To install an **Accent Pushbutton**, which, when pressed, causes every beat to be Accented, it suffices to install a normally closed switch, which goes open-circuit when pressed, in series with D12. This is **Mod B**, and we choose to do it at the anode end, since this is physically most convenient. The cut track is between the anode pads of D7 and D12. See photos above.

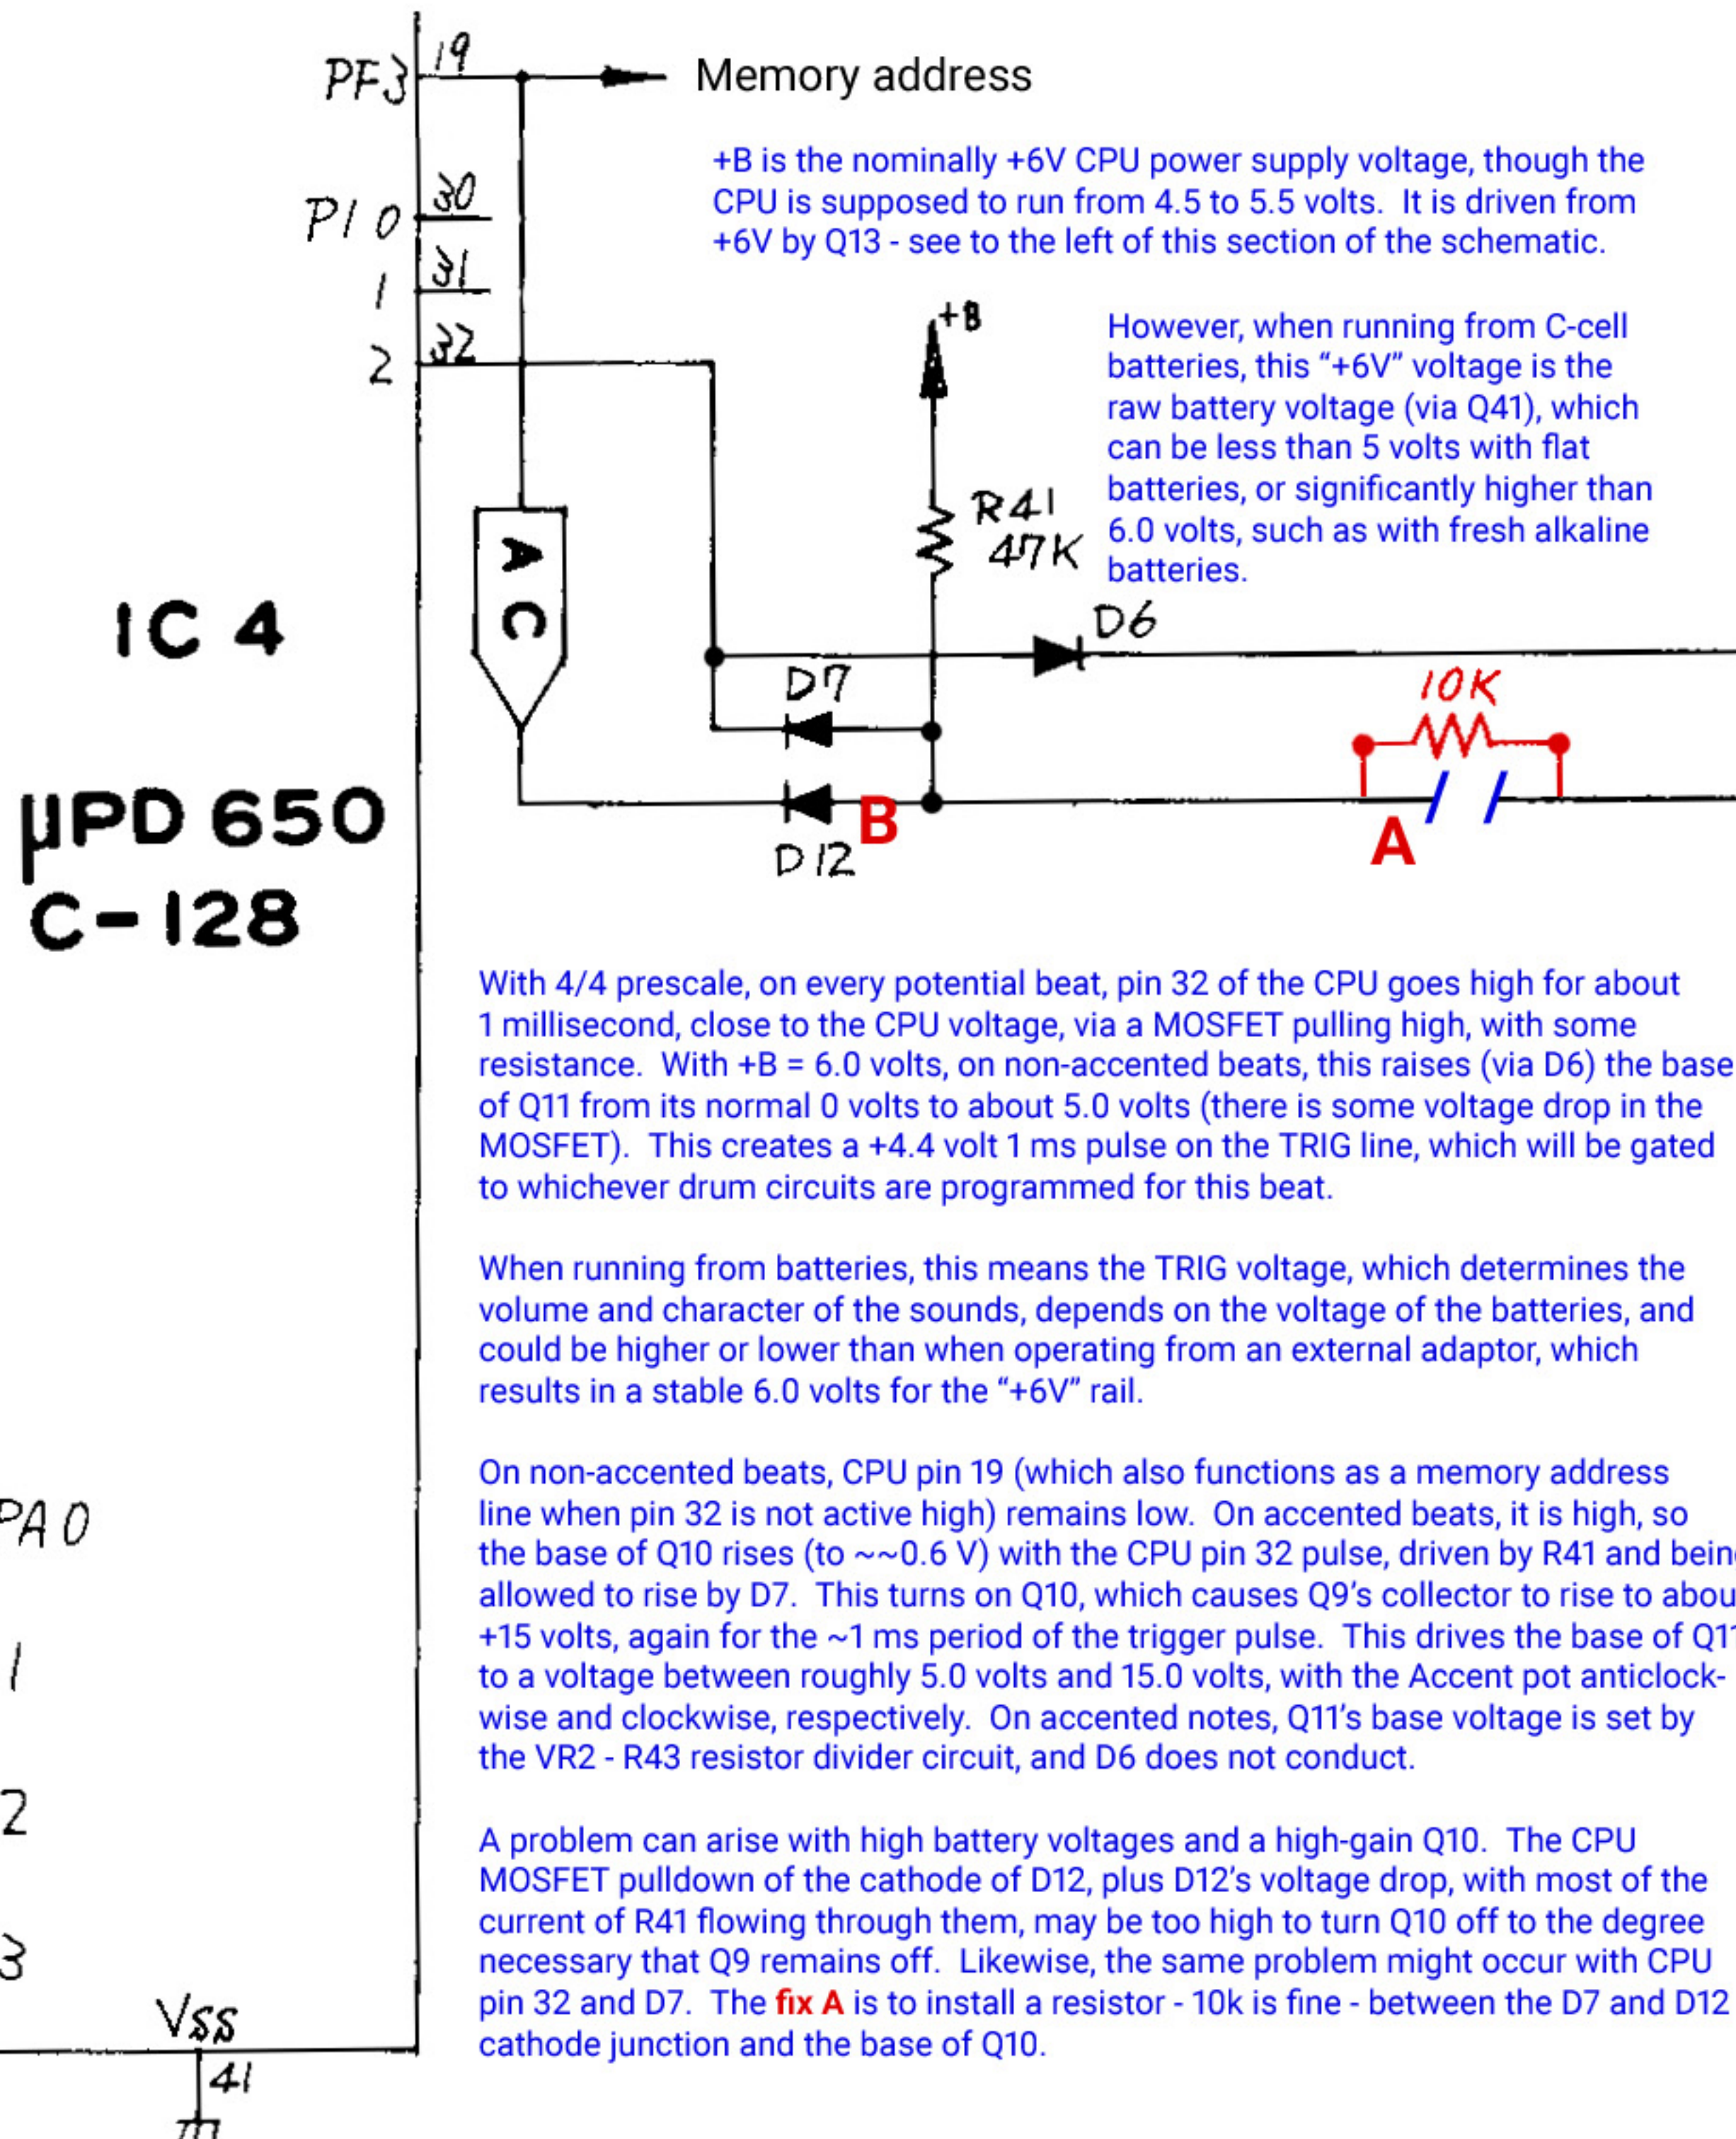
To avoid static electricity damage to the CPU, the metal body of the switch (I use a C&K 8125 SHZBE) should be grounded. I solder a wire to a lockwasher and connect it to a topside link wire just to the rear of D6, next to pin 8 of IC3, MC14001B = HD14001BP.
